Return loss at TP2 for CAUI-4 Chip to Module

March 6 2014

- **This presentation investigates the return loss specification at TP2 in 802.3bm draft 2.1 and compares it with the assumed ASIC and host specifications. It is in support of comment 48. A similar comment r01-49 was made against 802.3bj.**

Mated MCB/HCB S-parameter file

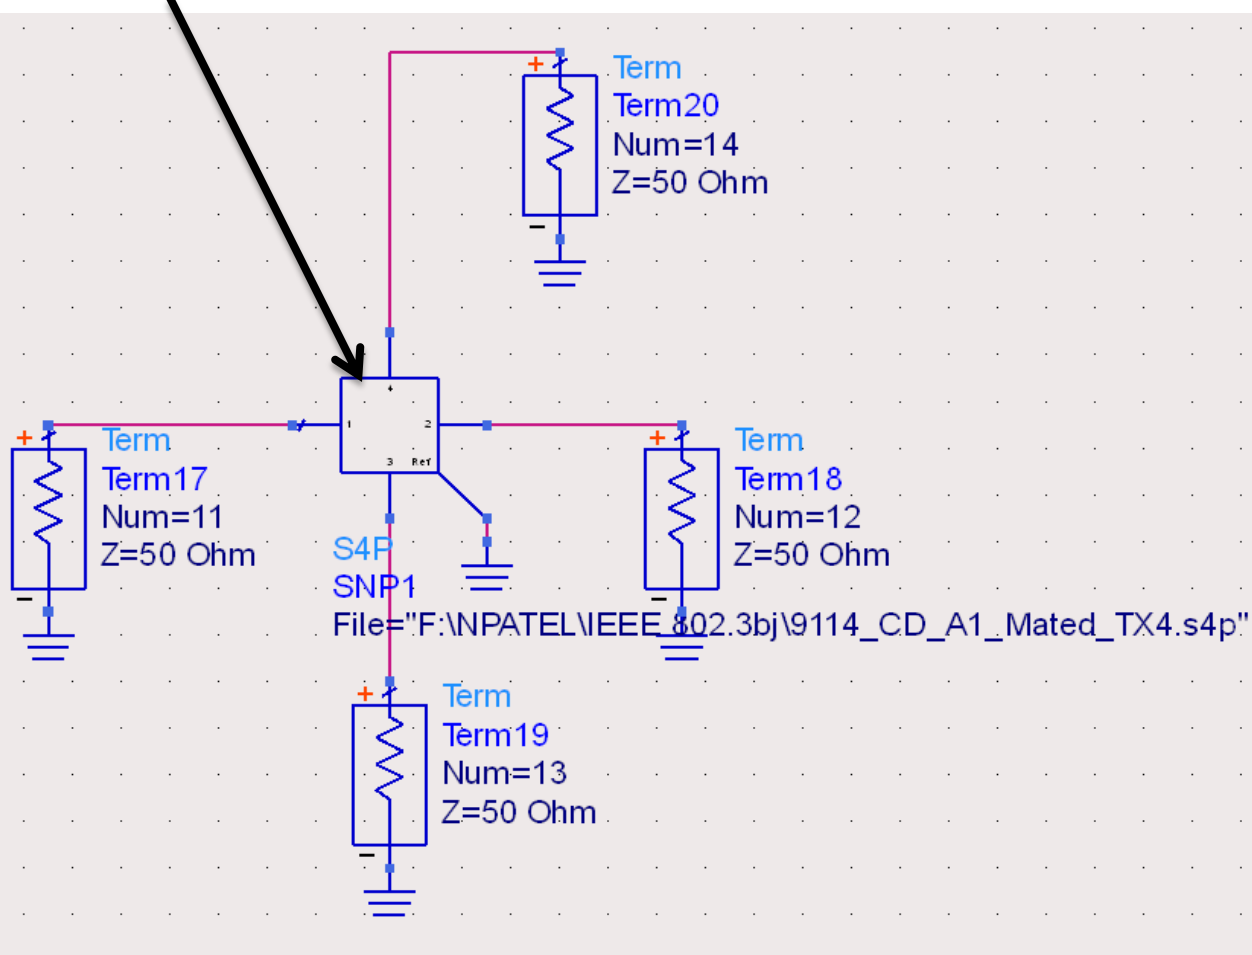
Mated MCB/HCB S-parameter file from C. Diminico. Note that it is expected that the out of spec return loss will be corrected with changes to the MCB

TP2 Return Loss – Method 2 (measured MCB/HCB)

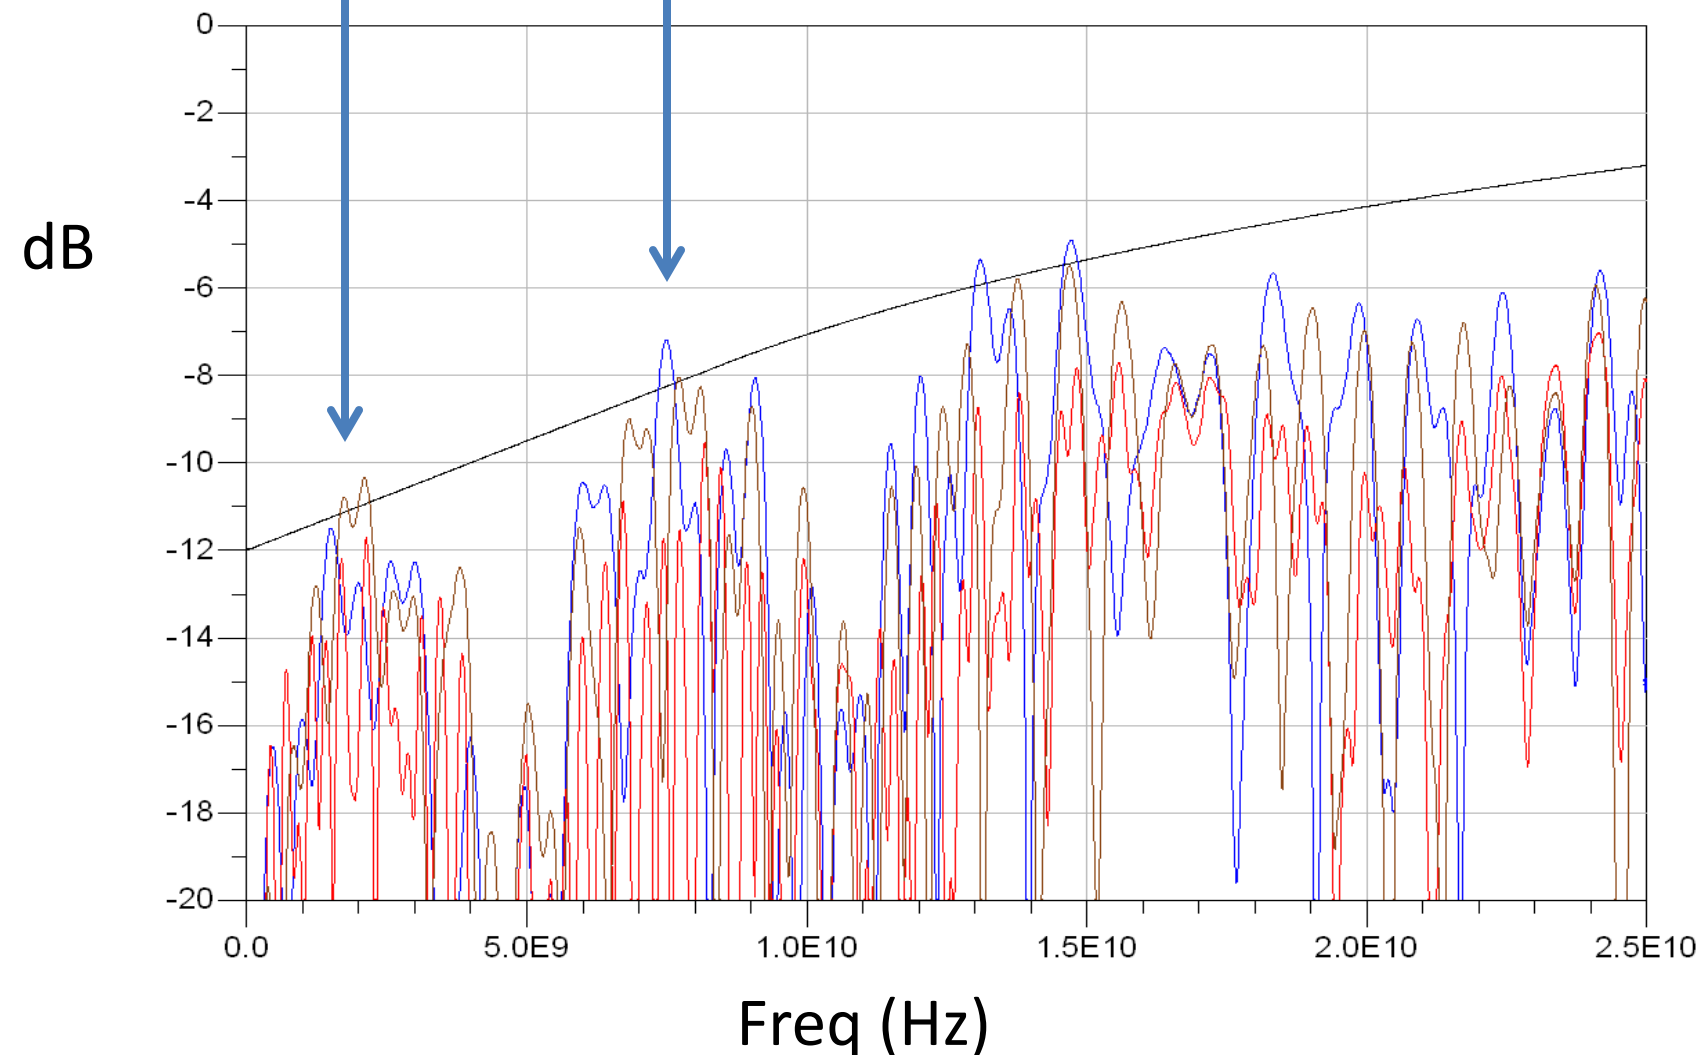
Fails spec at these frequencies even though HCB/MCB is in spec at these frequencies

Also note that the HCB is above 100 Ohm impedance whereas 90 Ohm impedance would be worst case.

- **There is an issue with a worst case Clause 93 IC and assumed host traces. The specification for the return loss at TP2 is not met with compliance boards that just meet their specification**
- **Proposal**
 1. As proposed in comment 48 the Host TP2 and TP3 (identical specification in equation 83E-5) should be relaxed to
$$\begin{array}{ll} 8.5 - 0.35 \times f & 0.01 \leq f \leq 8 \\ 3.9 - 7.4 \times \log_{10}(f/14) & 8 < f \leq 19 \end{array}$$
- **It is not proposed to change the module return loss specifications as it is expected that the module IC will be a smaller chip that can more easily meet the return loss specifications.**

TP2 Return Loss – Analytic Method

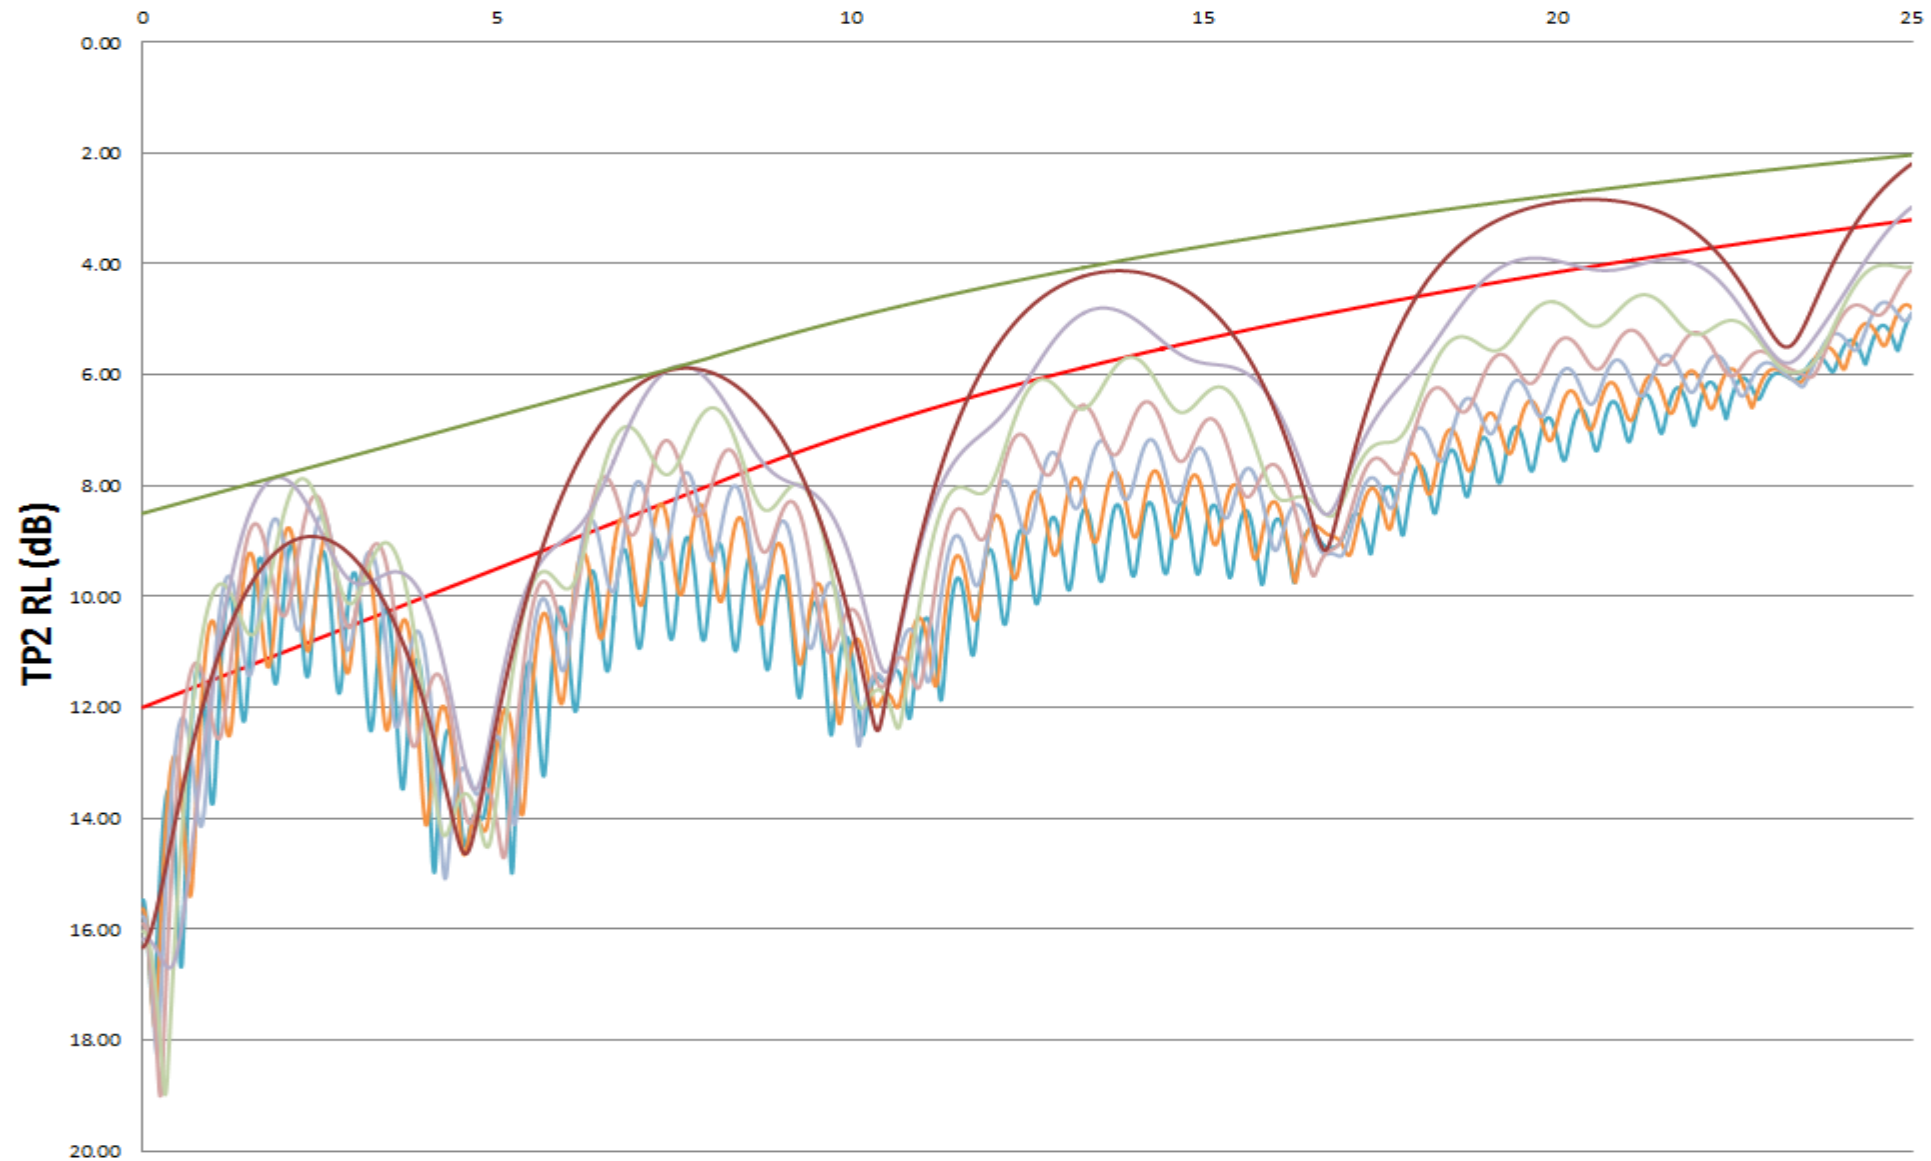
- Host RL SPEC
 - TP2 - RL @ 6.26dB
 - TP2 - RL @ 5.0dB
 - TP2 - RL @ 4.0dB
 - TP2 - RL @ 3.0dB
 - TP2 - RL @ 2.0dB
 - TP2 - RL @ 1.0dB
 - TP2 - RL @ 0dB
 - Proposed Host RL SPEC
- Host PCB loss is this loss plus the MCB loss
- $$8.5 - 0.35 \times f \quad 0.01 \leq f \leq 8$$
- $$3.9 - 7.4 \times \log_{10}(f/14) \quad 8 < f \leq 19$$

TP2 Return Loss – Method 2

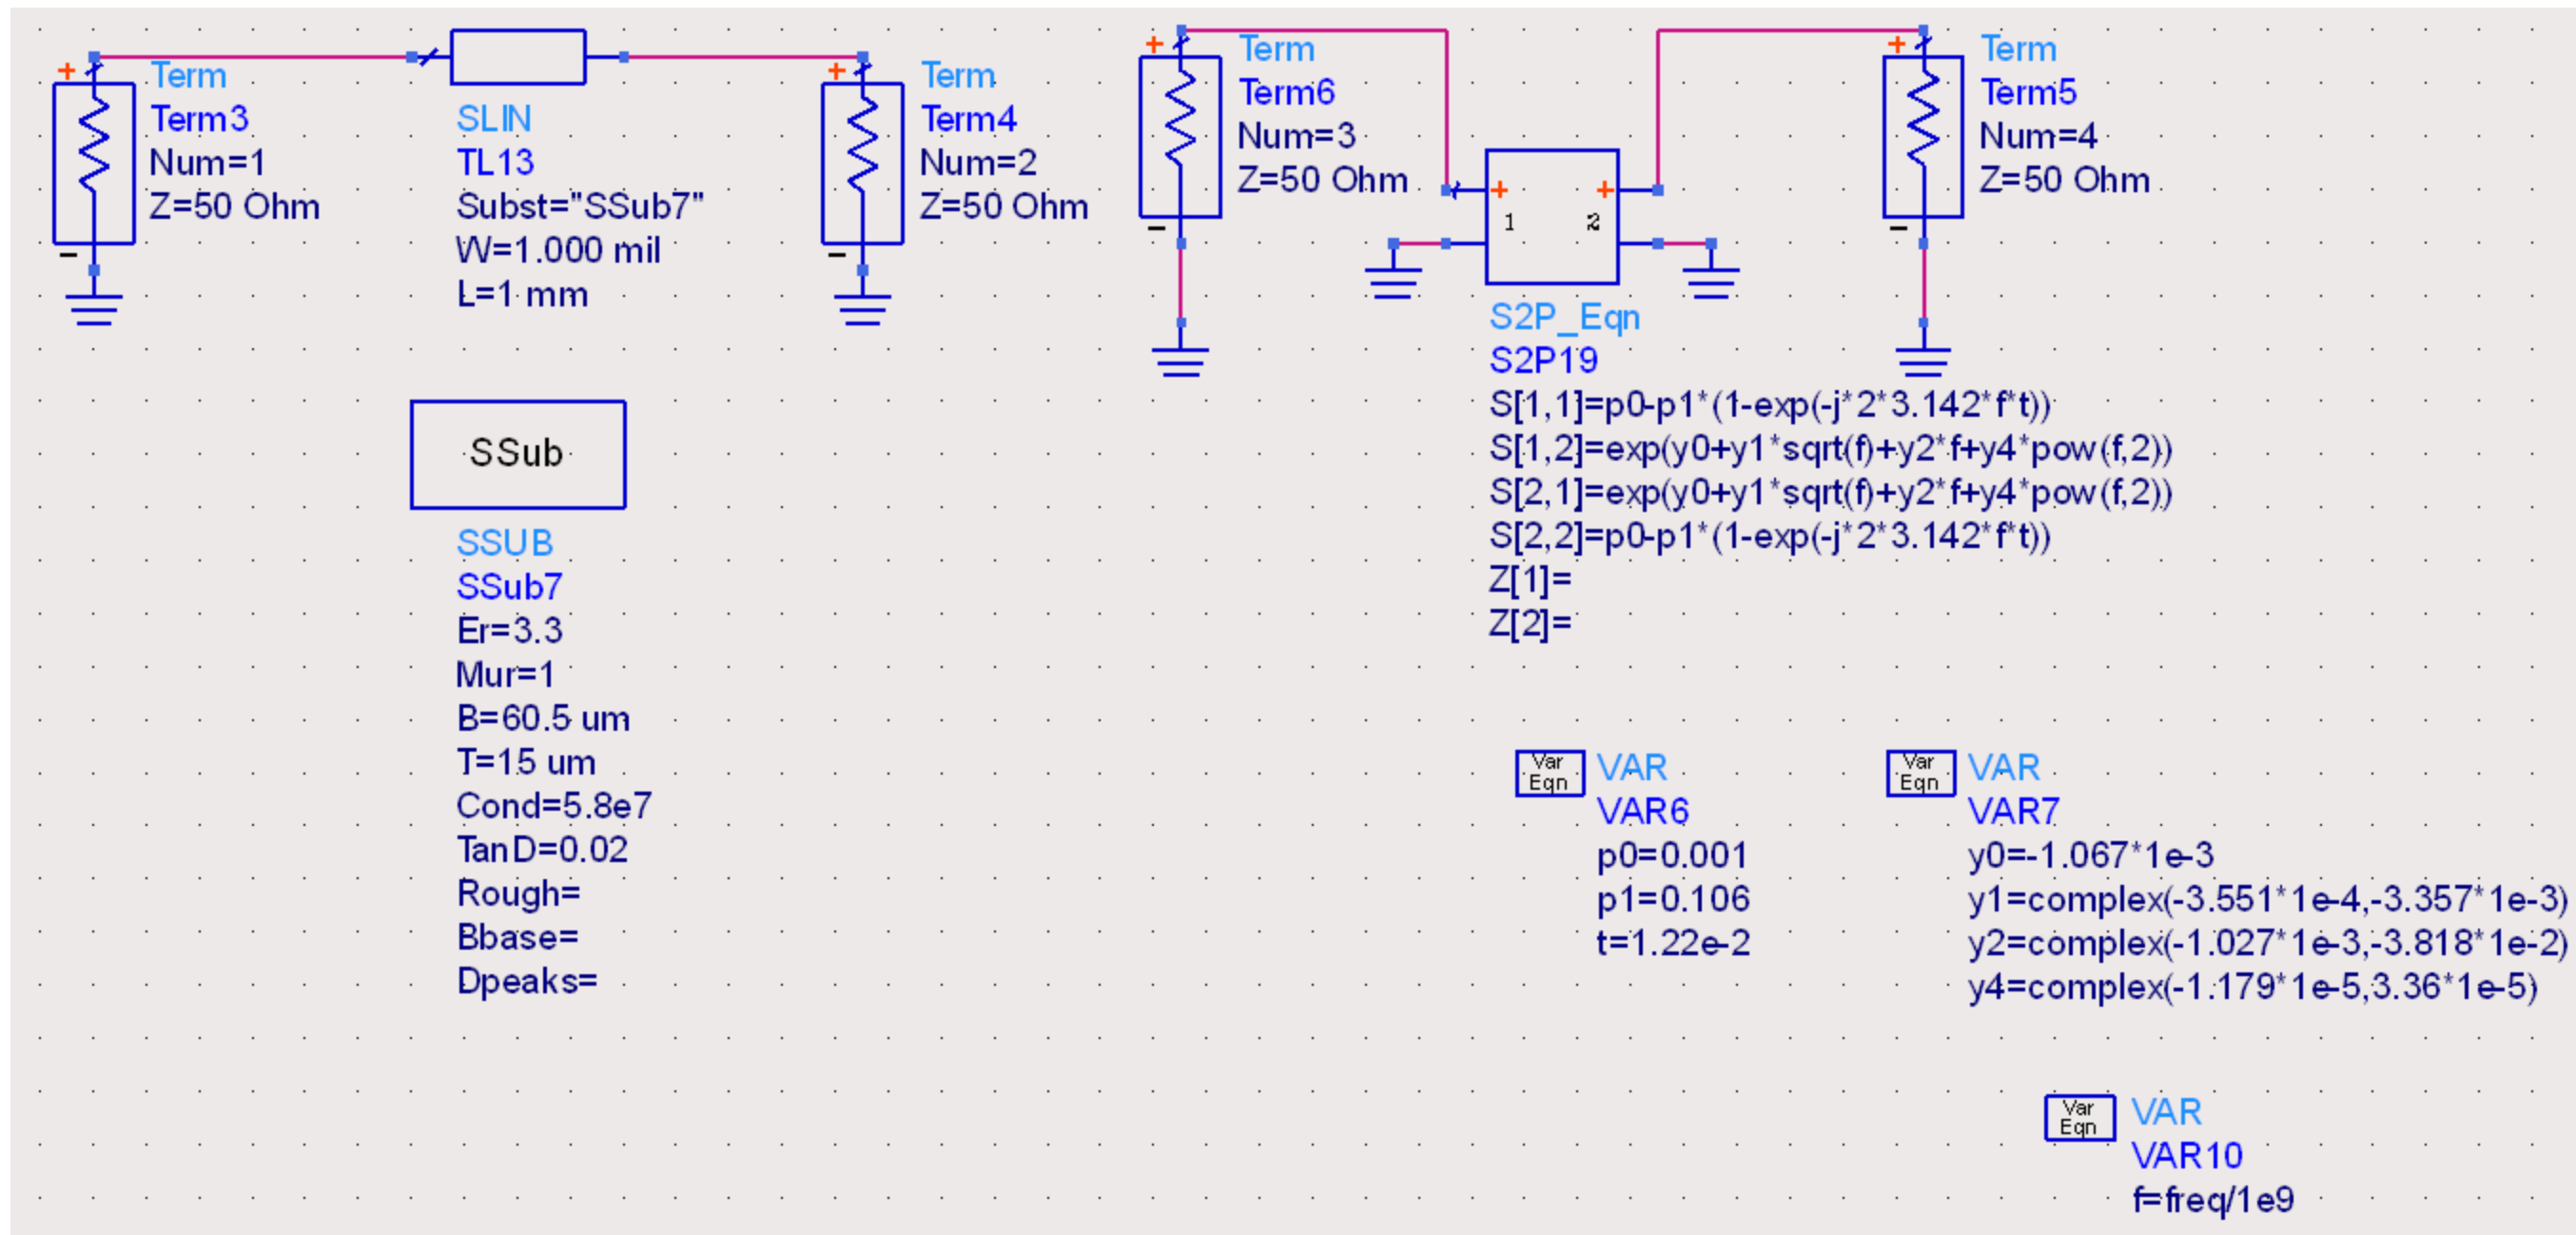
Black – Host RL Spec

Red – TP2 RL @ 6.26dB + MCB

Brown – TP2 RL @ 1dB + MCB

Blue – TP2 RL @ 0dB + MCB

Green – Proposed RL Spec

$$8.5 - 0.35 \times f \quad 0.01 \leq f \leq 8$$

$$3.9 - 7.4 \times \log_{10}(f/14) \quad 8 < f \leq 19$$
